NEW! CERTAIN 2004 THROUGH 2006 MODEL YEAR F-150 AND 2006 MODEL YEAR MARK LT VEHICLES — CLOCKSPrING TO DRIVER SIDE FRONTAL AIR BAG WIRE HARNESS REPLACEMENT

OVERVIEW

FIGURE 1

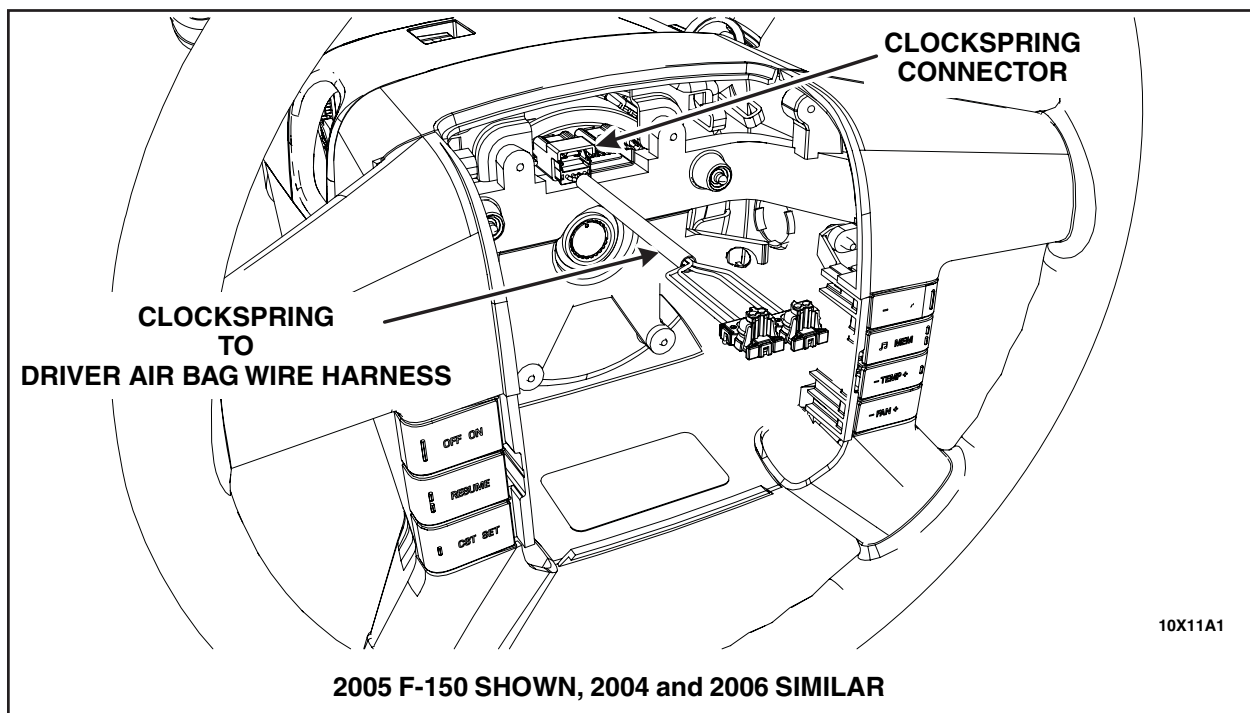
1. Remove the driver air bag. For additional information, refer to the appropriate WSM, Section 501-20B.
2. Release the clockspring connector lock and disconnect the harness from the clockspring. See Figure 1.

3. Install the **new** clockspring to driver air bag wire harness using the following sequence:
 1. Connect the harness to the clockspring.
 2. Make sure the harness lock at the clockspring is seated.
 3. Connect the harness to the air bag.
4. Install the driver air bag. For additional information, refer to the appropriate WSM, Section 501-20B.
